ADDENDUM NUMBER: ONE

**ISSUED BY: SEPW Architecture Inc.
206 – 1275 Broad Street, Regina, SK S4R 1Y2
PH. (306) 569-2255**

**PROJECT: ESDC – PPT REGINA AMALGAMATION
REGINA, SK**

A4.4R1

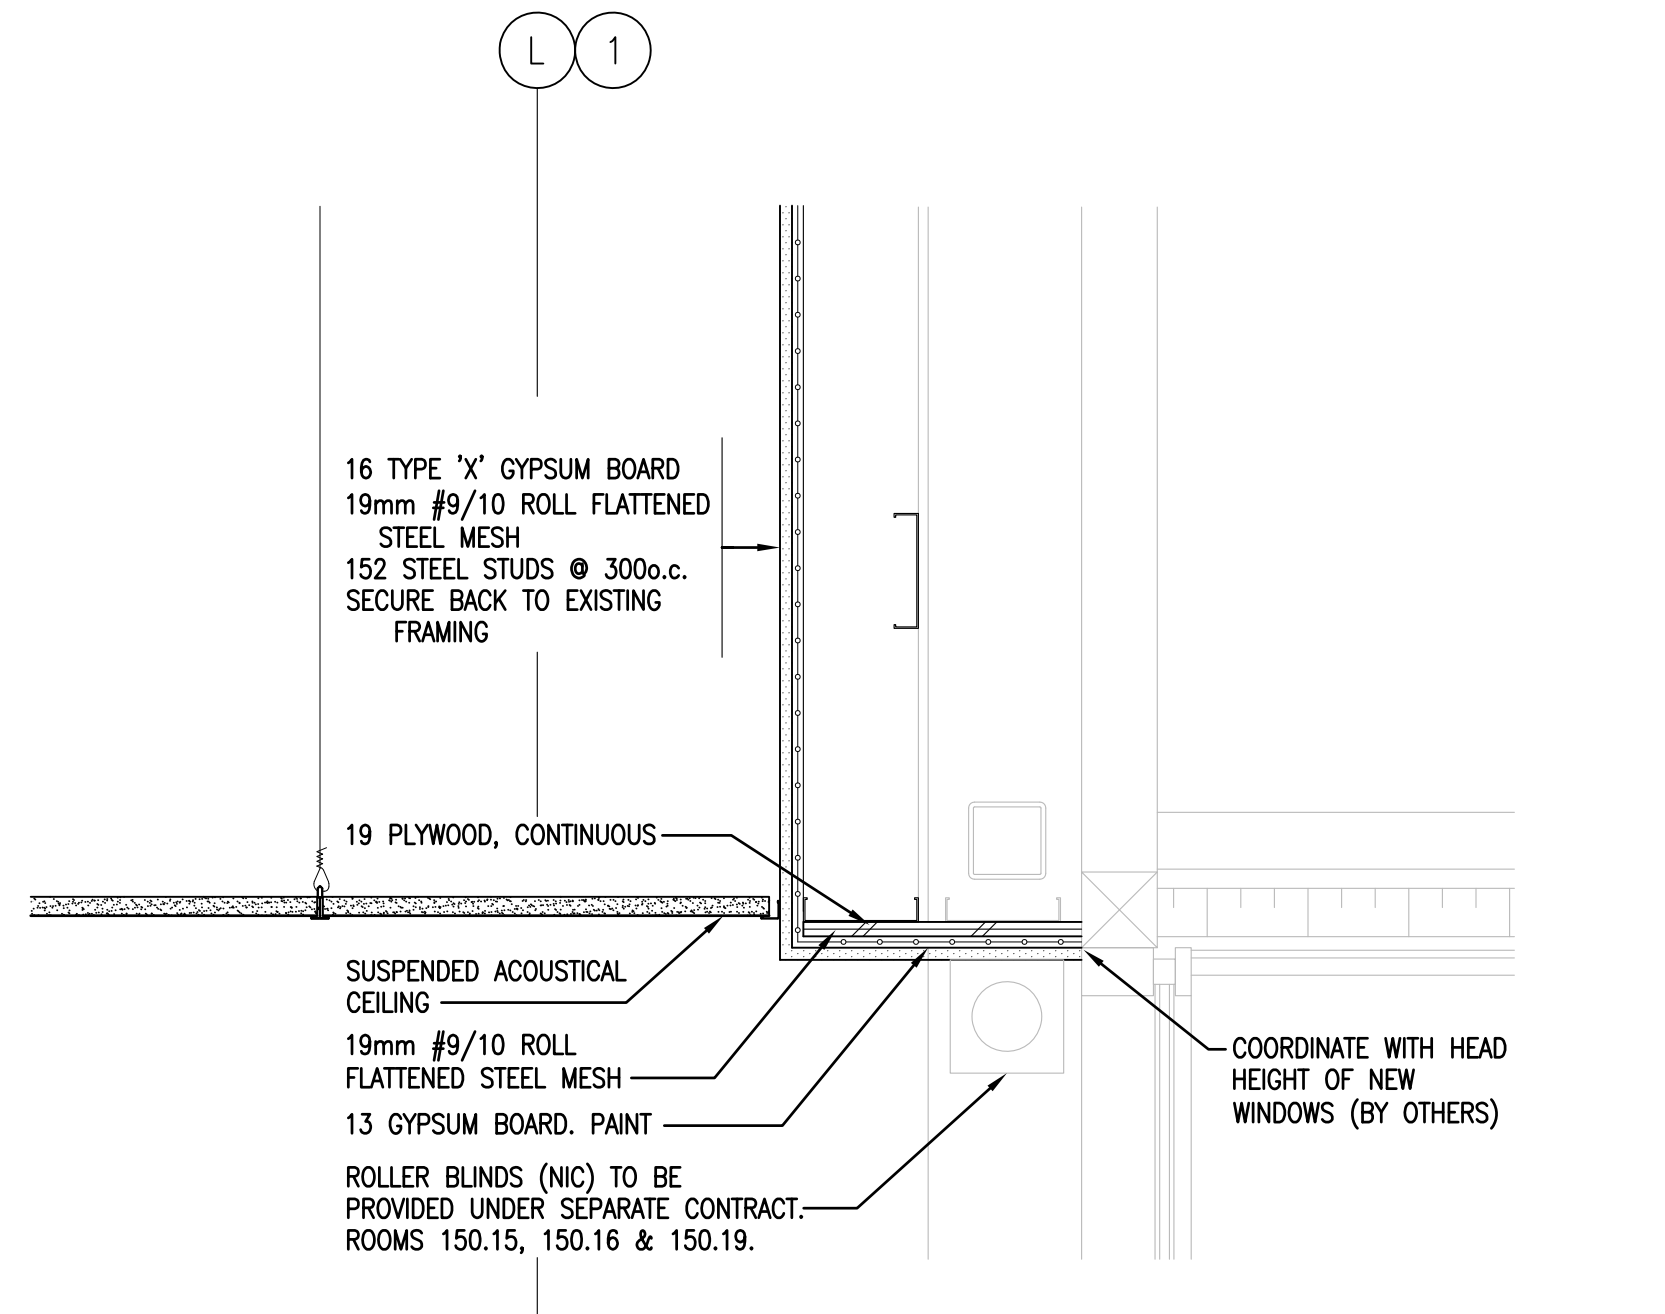
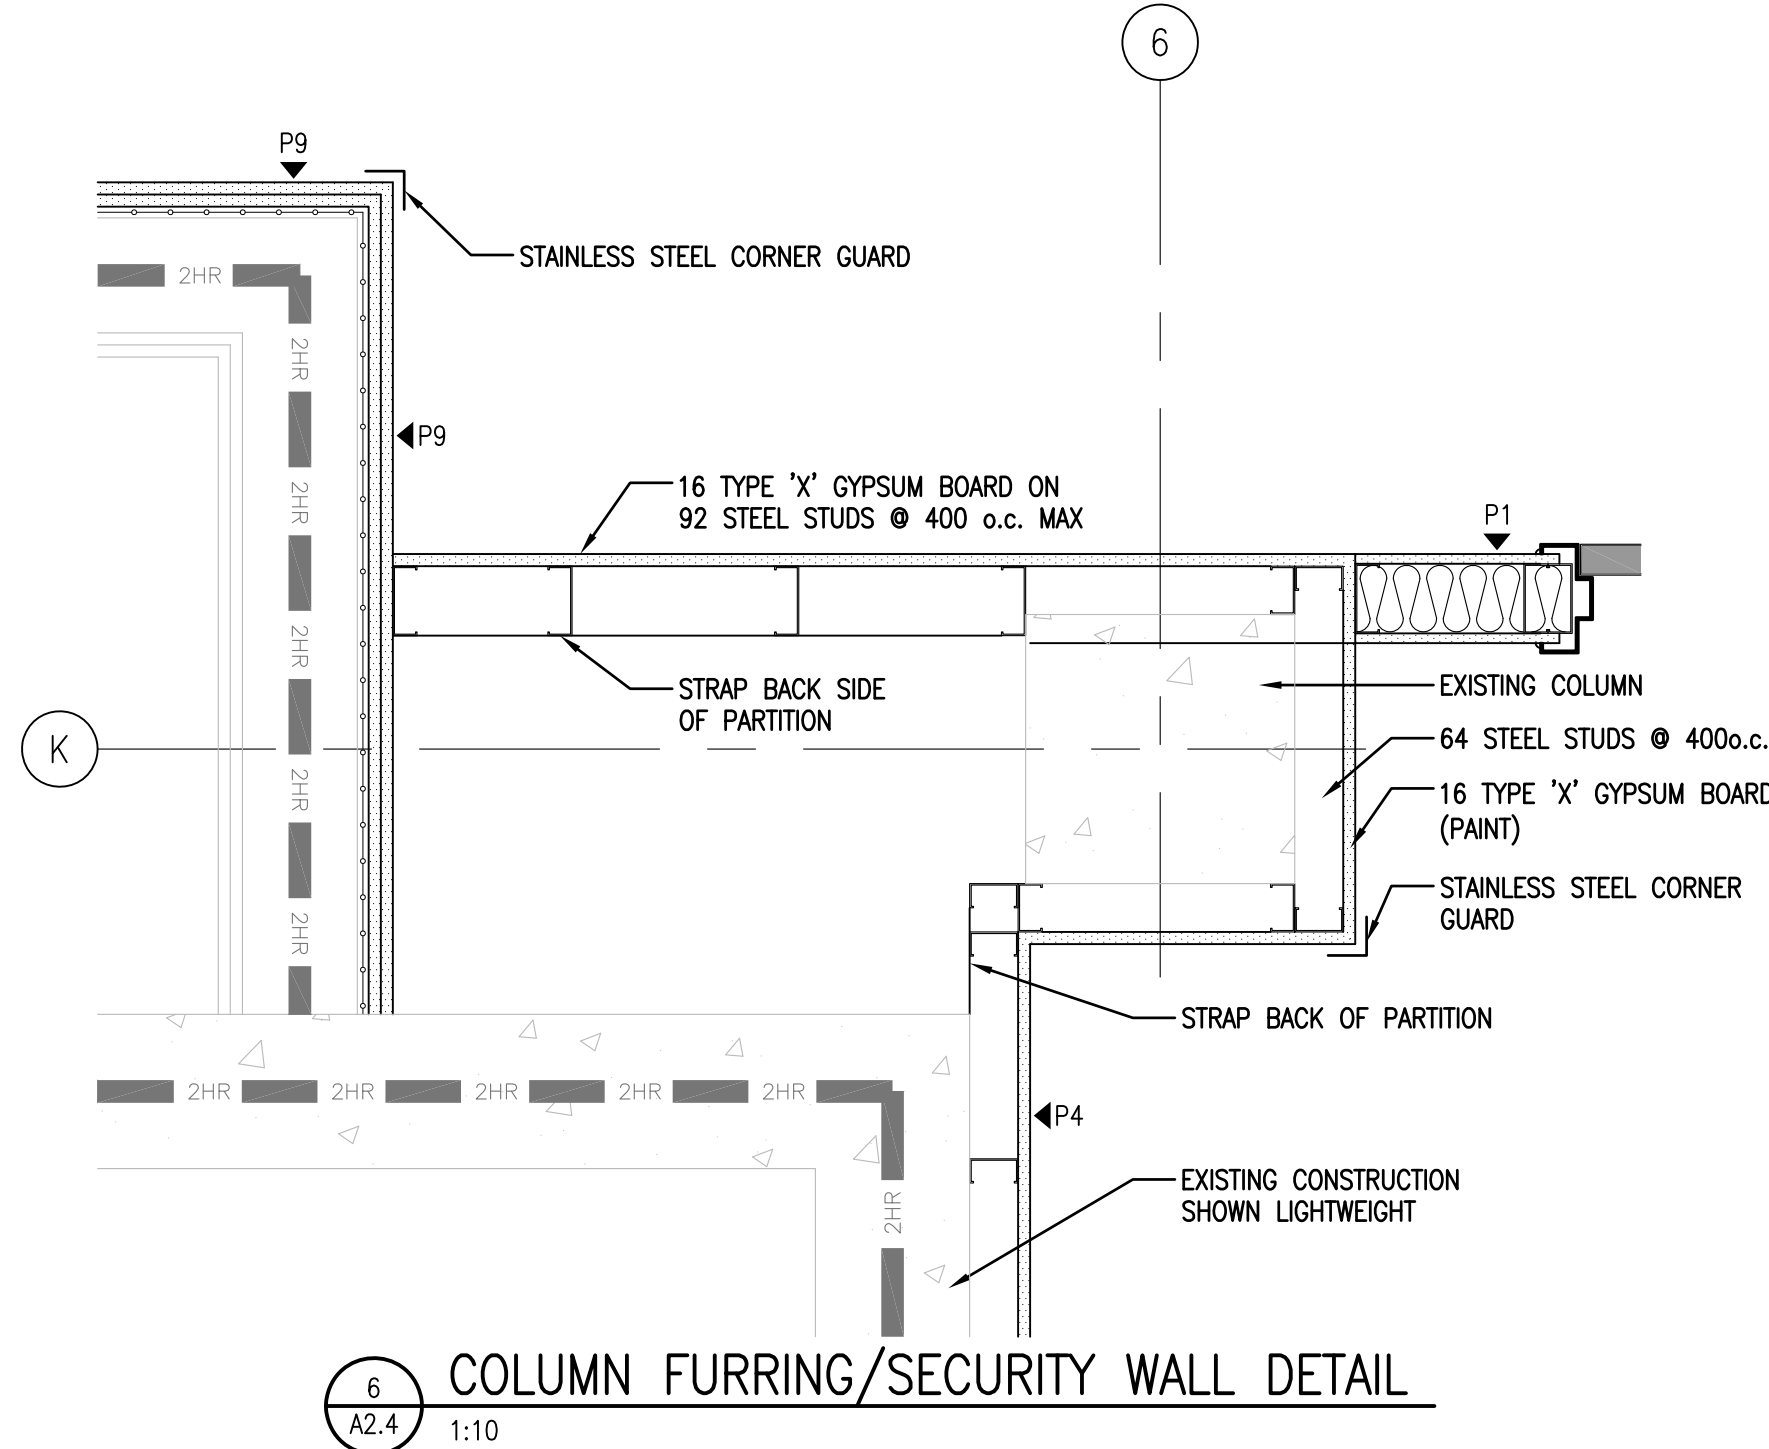
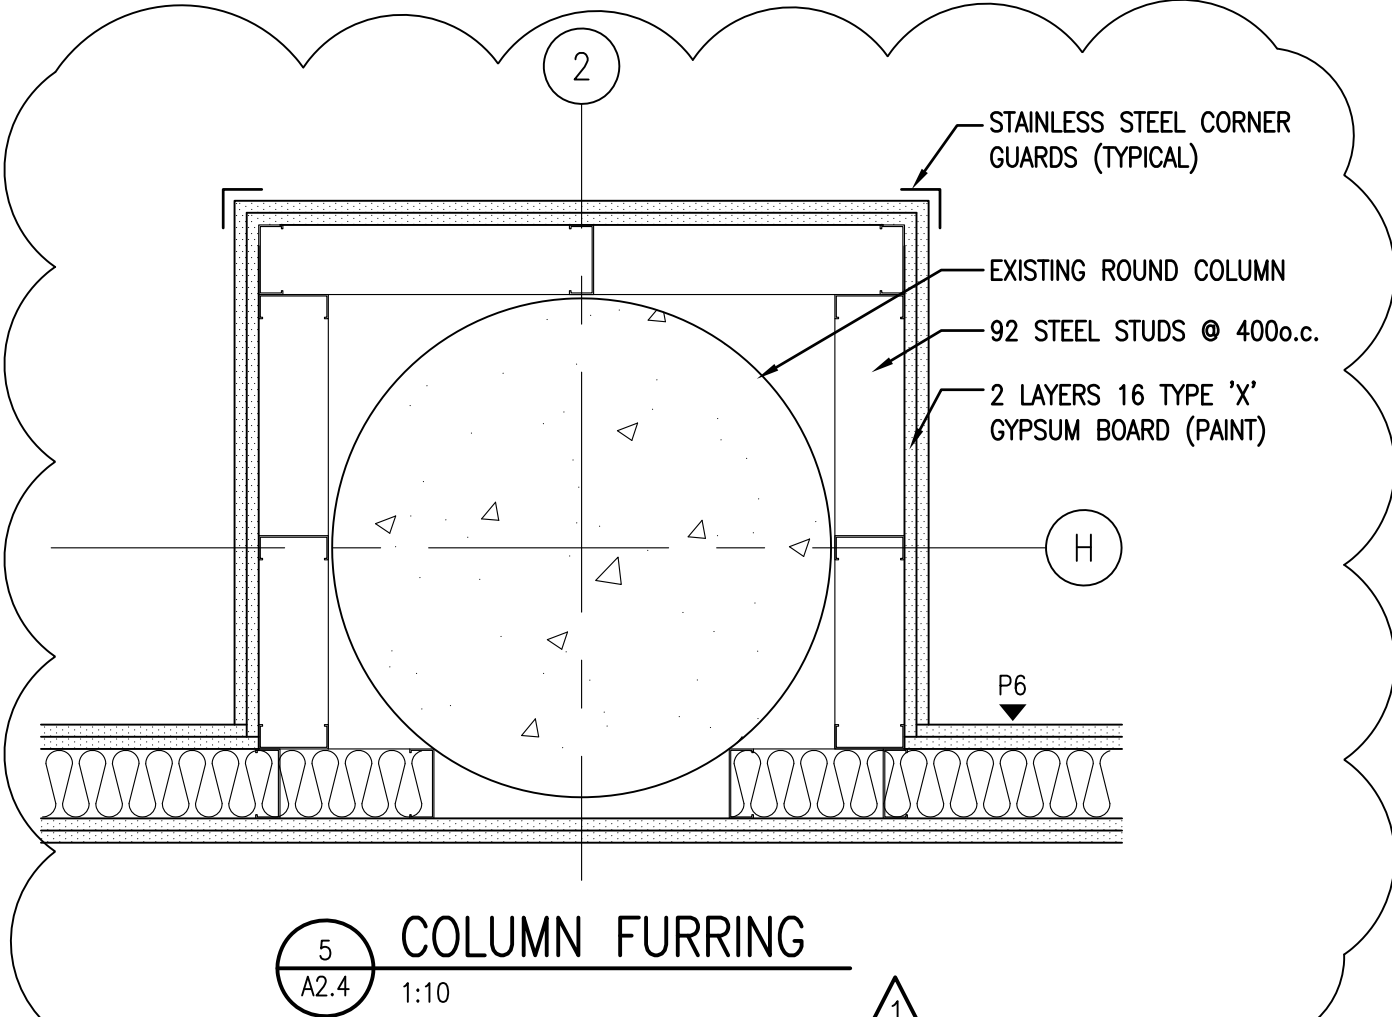
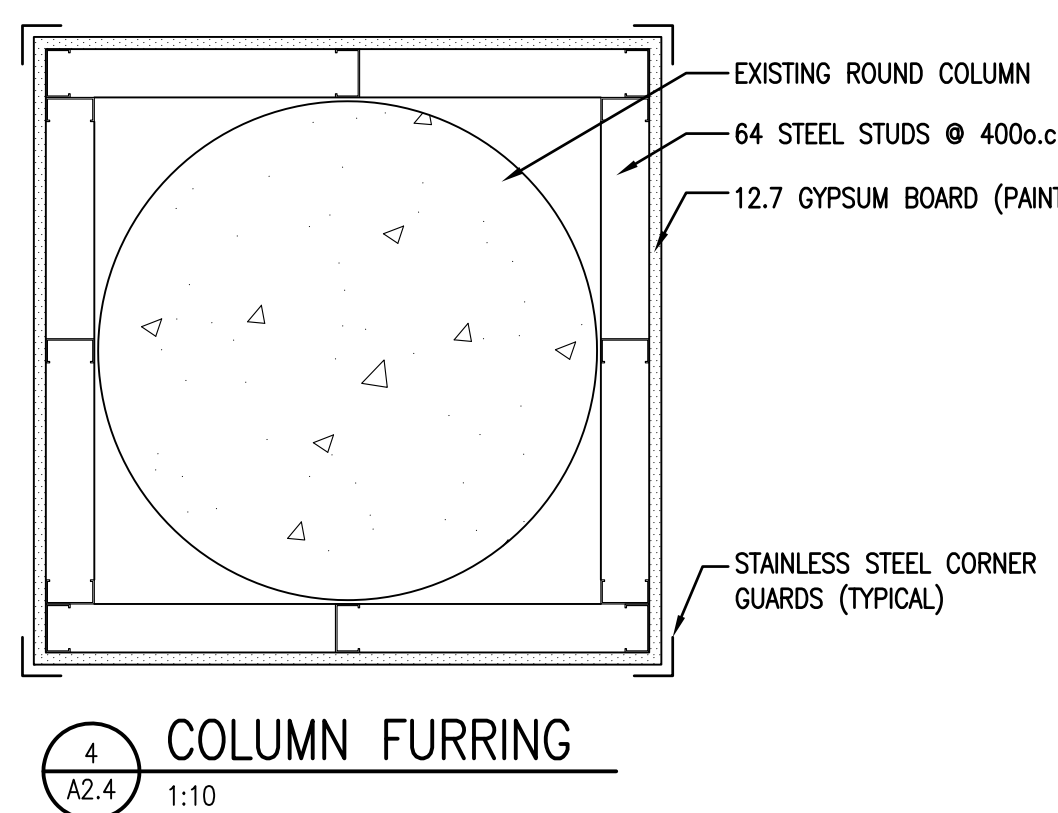
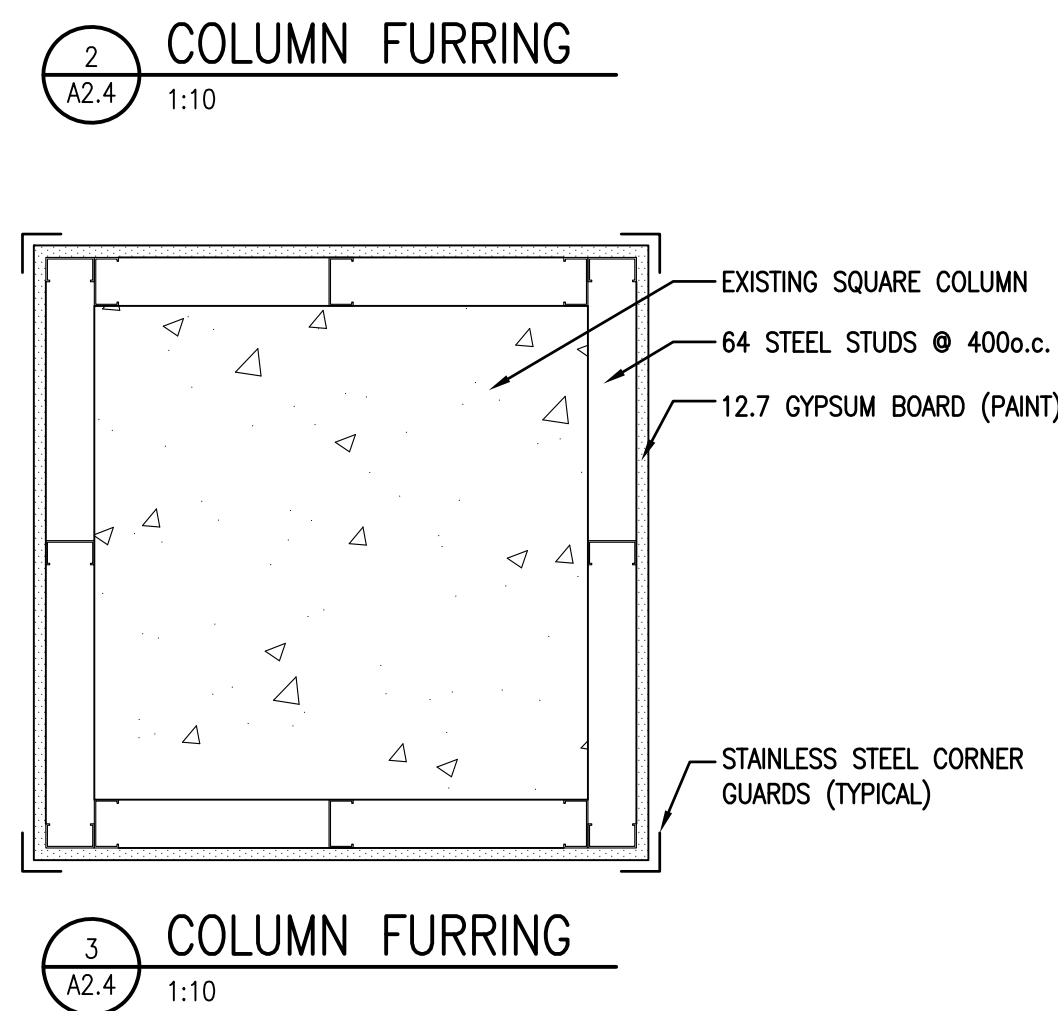
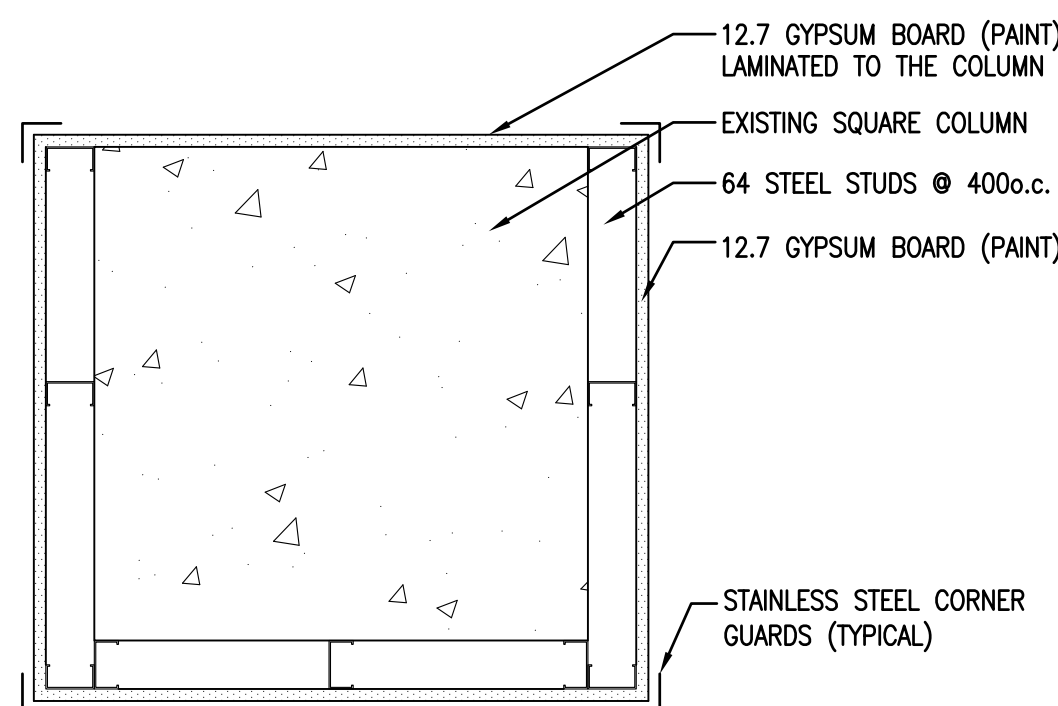
- .1 REPLACE this drawing in its entirety with Drawing A4.4R1 accompanying this addendum.
- .2 Reference Detail 5, Column Furring; REPLACE this detail as per Drawing A4.4R1 accompanying this addendum.
